**Re: Addendum No. 1 to the South Orange County Reliability Enhancement Project Notice to Proceed Request No. 2.**

**FIGURE 1  
SAN JUAN CAPISTRANO  
SUBSTATION  
NTP-2 Addendum - Attachment A**

**ATTACHMENT B**  
**NTP-2 Addendum Site Photographs**

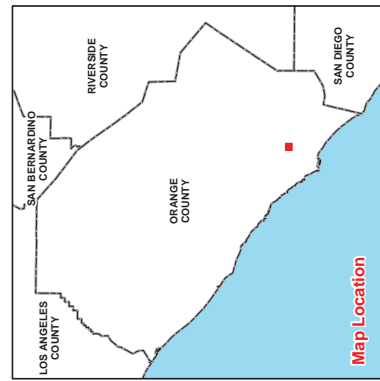
<sup>1</sup> Figure 1 depicts the proposed alignment of the relocated interior fence. The actual fence alignment may change slightly due to clearance requirements from the existing transmission equipment located in the upper yard.

interior fence from what was previously approved in NTP-2 that would allow for use of a larger area.

SDG&E respectfully requests approval of Addendum No.1 to NTP-2 to include a modified alignment of the relocated interior fence, removal of the three 138-kV rack structures and associated hazardous materials abatement activities in the upper yard of the San Juan Capistrano Substation as conditioned in the CPUC's NTP-2 approval letter and any pending pre-construction requirements. Should you have any questions or need additional information, please do not hesitate to contact me at (858) 503-5028 or by email at [jkaminsky@semprautilities.com](mailto:jkaminsky@semprautilities.com).

\* The actual fence alignment may change slightly due to clearance requirements from the existing transmission equipment located in the upper yard.
